ICHD - ENVIRONMENTAL HEALTH DIVISION

Statesville Office (704) 878-5305 | Mooresville Office (704) 660-3625 | PERMIT # ~~AP~~ OSWP-2022-2100

SEPTIC: IMPROVEMENT PERMIT / AUTHORIZATION TO CONSTRUCT / OPERATION PERMIT / EXISTING SYSTEM

MICHAEL ATHANAS & ASSOCIATES
LICENSED SOIL SCIENTIST
556Walden Trail
Weddington, NC 28173
(704) 576-3887
8/17/2022

INITIAL SITE SKETCH

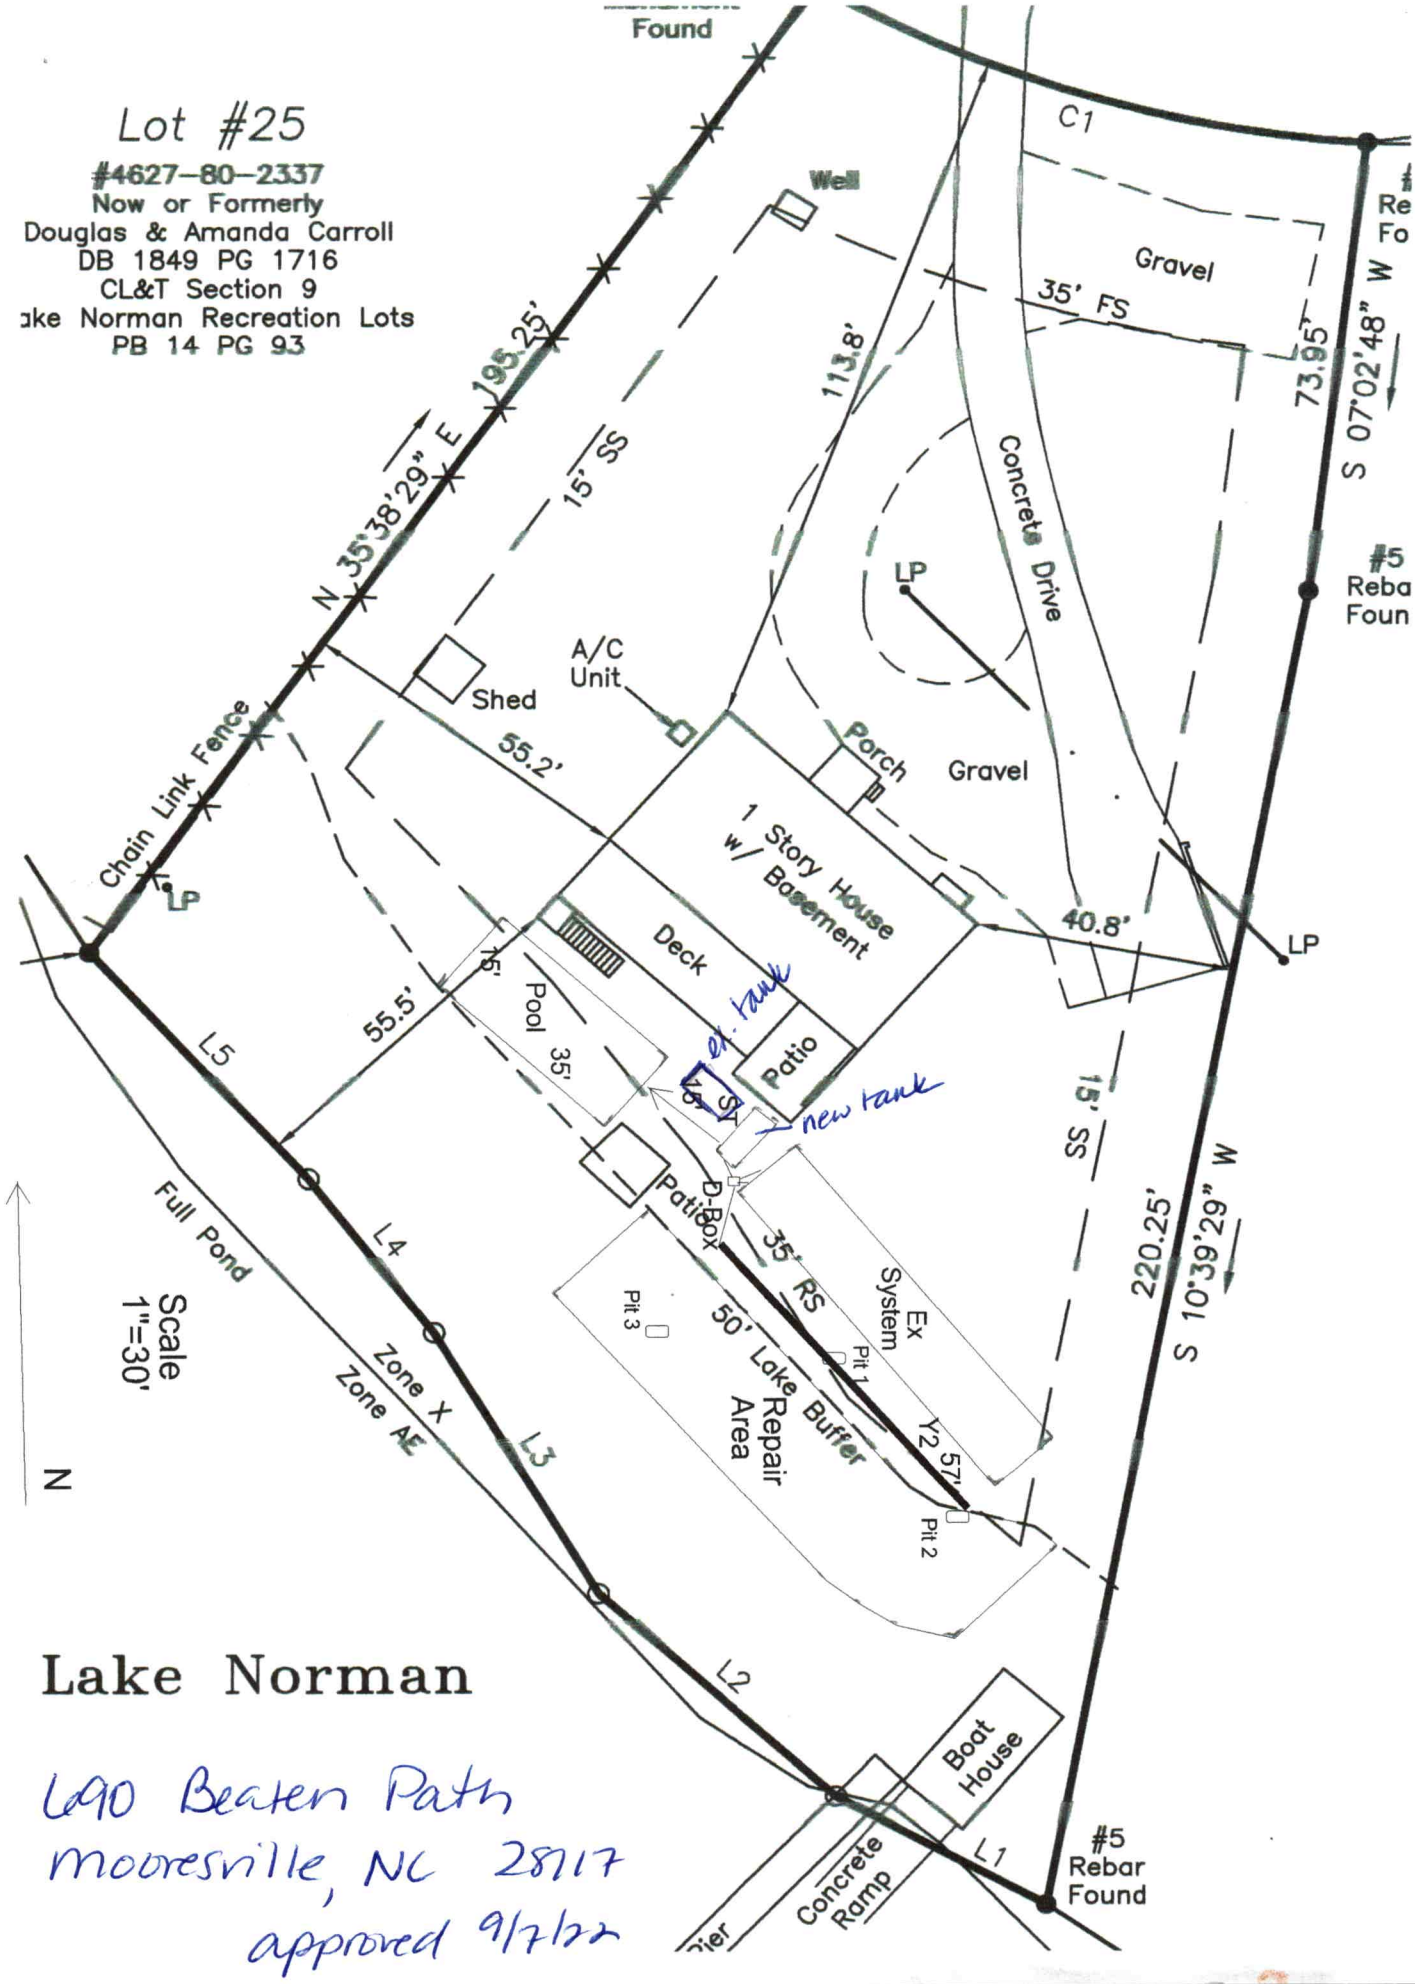
Comments / Conditions: Pump, crush & fill existing tank, Replace distribution to feed as shown on plan.

50' buffer & pool area must be staked during installation.
